UNITED STATES
DEPARTMENT OF THE INTERIOR
BUREAU OF LAND MANAGEMENT**SUNDRY NOTICES AND REPORTS ON WELLS**
*Do not use this form for proposals to drill or to re-enter an abandoned well. Use form 3160-3 (APD) for such proposals.*FORM APPROVED
OMB NO. 1004-0137
Expires: January 31, 20185. Lease Serial No.
NMLC032511F ✓

7. If Unit or CA/Agreement, Name and/or No.
NMNM87877X ✓8. Well Name and No.
SJU 12 ✓9. API Well No.
30-025-20995-00-S110. Field and Pool or Exploratory Area
JUSTIS11. County or Parish, State
LEA COUNTY, NM**SUBMIT IN TRIPLICATE - Other instructions on page 2**1. Type of Well
☒ Oil Well ☐ Gas Well ☐ Other2. Name of Operator
LEGACY RESERVES OPERATING LP
Contact: JOHN SAENZ
E-Mail: jsaenz@legacyp.com3a. Address
303 W WALL SUITE 1600
MIDLAND, TX 797023b. Phone No. (include area code)
Ph: 432-689-52004. Location of Well (Footage, Sec., T., R., M., or Survey Description)
Sec 11 T25S R37E SWNW 1650FNL 990FWL ✓
32.147509 N Lat, 103.138980 W Lon**12. CHECK THE APPROPRIATE BOX(ES) TO INDICATE NATURE OF NOTICE, REPORT, OR OTHER DATA**

**Legacy Reserves Operating L.P.
South Justice Unit - 12, API 3002520995
T25S-R37E, Sec 13, 1650FNL & 990FWL
July 13, 2017**

Wellbore Schematic (From Surface to TD)

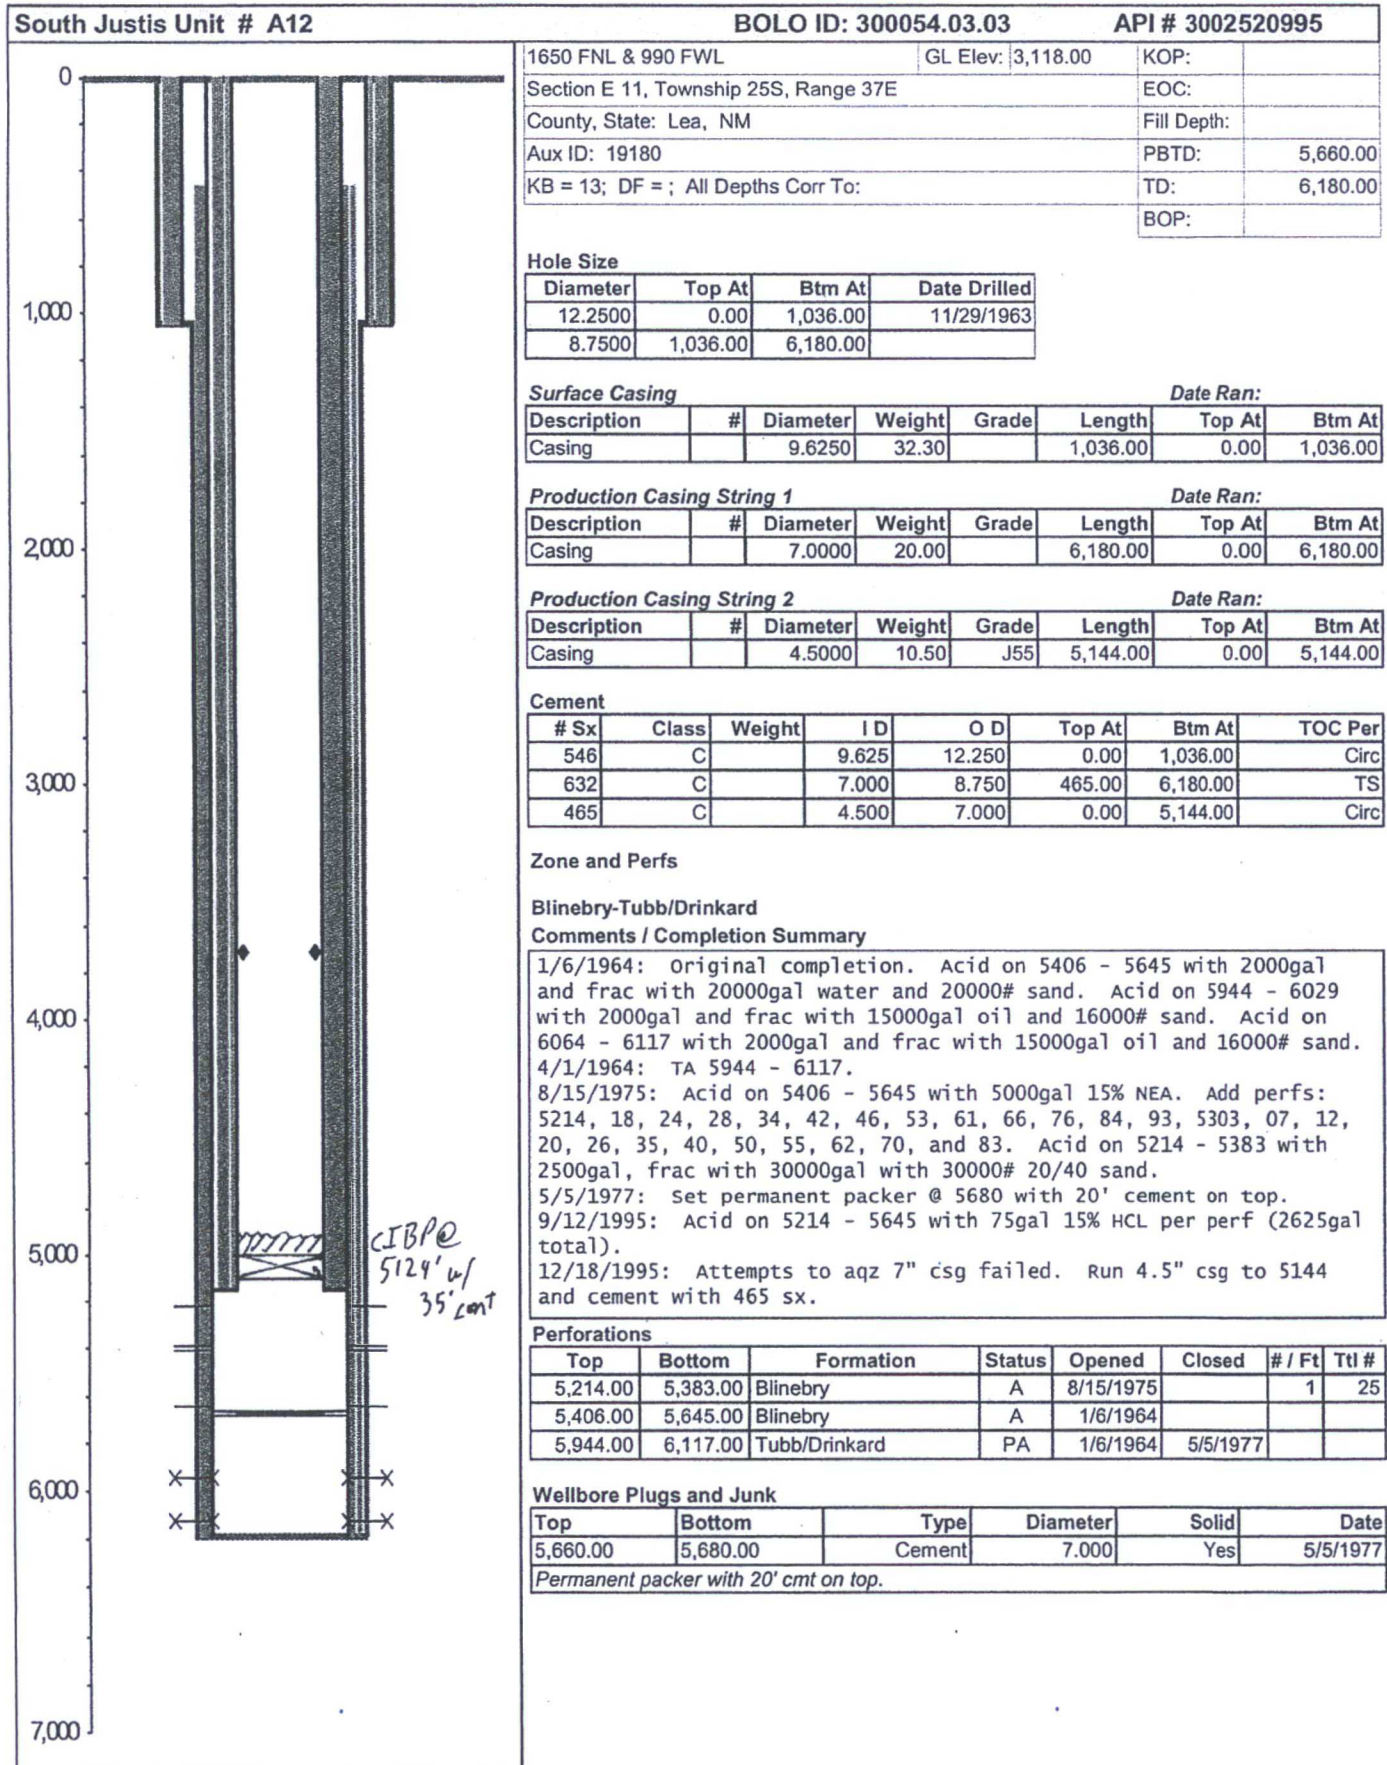
Procedure:
Set CIBP @ 5124' and cap with 35' cement. Contact BLM. Perform MIT test.

Current & proposed wellbore diagrams attached.

Wellbore Schematic (From Surface to TD)

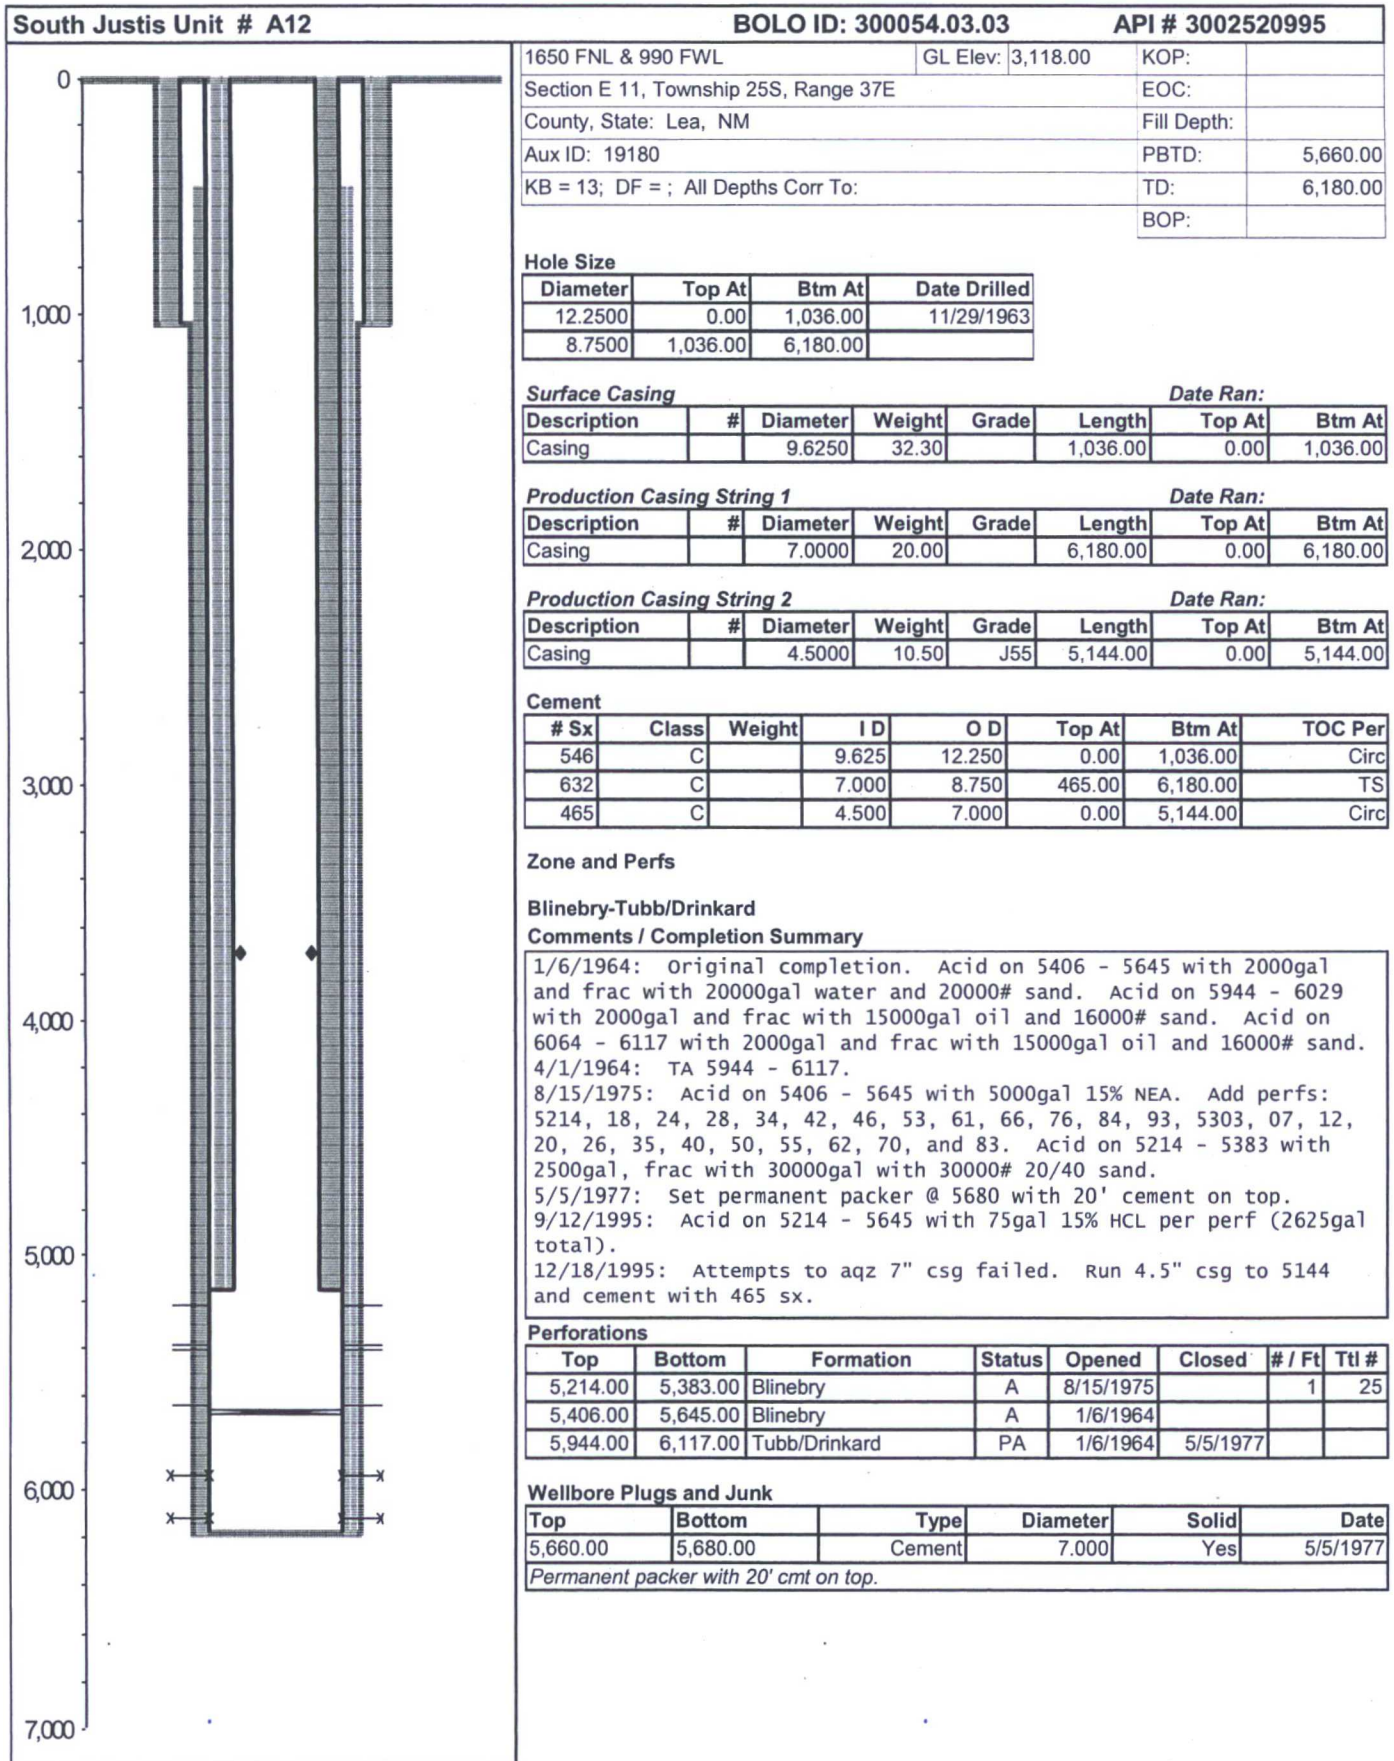
- a. All downhole production artificial lift equipment (tubing, rods, etc.) removed from wellbore.
- b. **A balanced cement plug on the Pkr at 5660. WOC and tag with tubing at 5500 or above.**

- c. **The proposed CIBP at 5124 capped with 35' cement.**
- d. MIT - at least 24 hours prior contact the appropriate BLM office. Eddy County call Carlsbad 575-361-2822. Lea County call Hobbs 575-393-3612.

- i. No sundry record found for the operator submitted 12/18/1995 comment concerning 4 1/2" csg being set to 5144. **File a separate dated detailed sundry describing that operation.**
